Access Compliance Report

Public Rights-of-Way

(Curb Ramps)

Intersection ID: N/A	Main Street: SOLAR_WY	Cross Street: ROCK_ISLAND_RD	Location: SW
ADA ID: 4D328F137608	Ramp Type: Perp	Initial Pass/Fail: Fail	Overall Compliance: No
Codes/Mitigation Info/Possible Solution		Field Measurements/Component Compliance	
Severity Score: 12.5

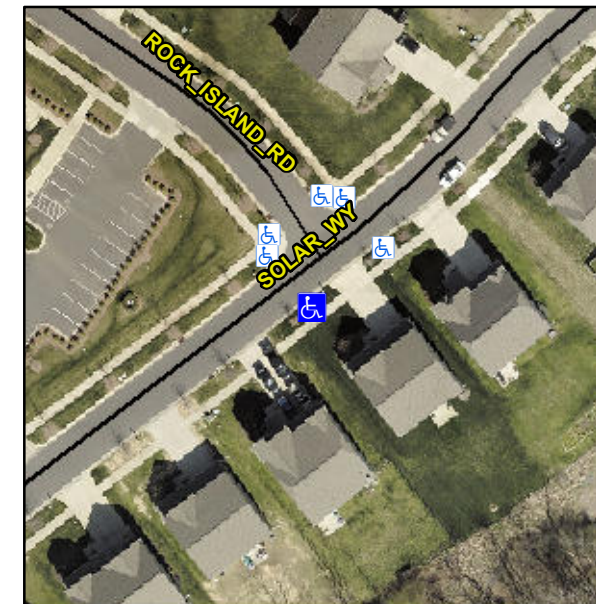
Not Found, R304.5.3

Compliance	Description	Data	Compliance	Description	Data
N/A	Ramp Length (in)	95.0	Yes	Ramp Slope (%)	5.6
Yes	Ramp Width (in)	48.0	No	Ramp XSlope (%)	5.8
N/A	Flare Type LT	N/A	N/A	Flare Type RT	N/A
N/A	Flare Slope LT (%)	N/A	N/A	Flare Slope RT (%)	N/A
N/A	Flare Traversable LT?	N/A	N/A	Flare Traversable RT?	N/A
N/A	Landing Length (in)	N/A	N/A	DWS Provided?	N/A
N/A	Landing Width (in)	N/A	N/A	DWS Contrast?	N/A
N/A	Landing Slope (%)	N/A	N/A	DWS Length (in)	N/A
N/A	Landing X Slope (%)	N/A	N/A	DWS Full Width?	N/A
N/A	Landing Curb? (Y/N)	N/A	N/A	DWS Offset (in)	N/A
N/A	Shared Landing?	N/A			
N/A	Gutter Ponding?	N/A	N/A	Gutter Slope (%)	N/A
N/A	Gutter Lip Ht (in)	N/A	N/A	Gutter X Slope (%)	N/A
N/A	Painted X Walk1?	No	N/A	Painted X Walk2?	N/A
	X Walk 1 Direction	To NW		X Walk 2 Direction	N/A
N/A	X Walk 1 Width (in)	N/A	N/A	X Walk 2 Width (in)	N/A
	X Walk 1 Slope (%)	4.2		X Walk 2 Slope (%)	N/A
	X Walk 1 X Slope (%)	4.8		X Walk 2 X Slope (%)	N/A

Remove & Replace Entire Ramp.
